Service Note		
Product	Description:	Service note no.
TC2290	"Scratch" When Turning Gain-pot:	706 10 T067

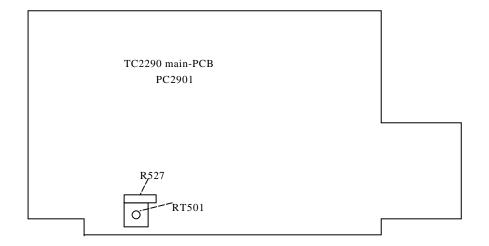
IMPORTANT: When having 2290s with s.no. lower than 510335 for repair or service please make this correction.

Please cut out R527 that are placed just besides of the RT501. Removing R527 will eliminate the sound to "Scratch" when turning the gain-pot.
